Access Compliance Report

Public Rights-of-Way

(Pedestrian Signals)

Intersection ID: N/A	Main Street:	Cross Street: N/A	Location: N/A
ADA ID: 414EB2F09766	Signal Type: One Push Button-Non APS	Overall Compliance: No	Severity Score: BTN 1: N/A BTN 2: N/A No BTN: N/A
Codes/Mitigation Info/Possible Solution		Field Measurements/Component Compliance

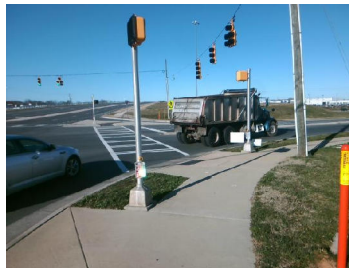
PROW/ADA: R404.2, R404.3, R406.2

Possible Solutions: Provide Push Button Extension. Remove and Replace Clear Space.
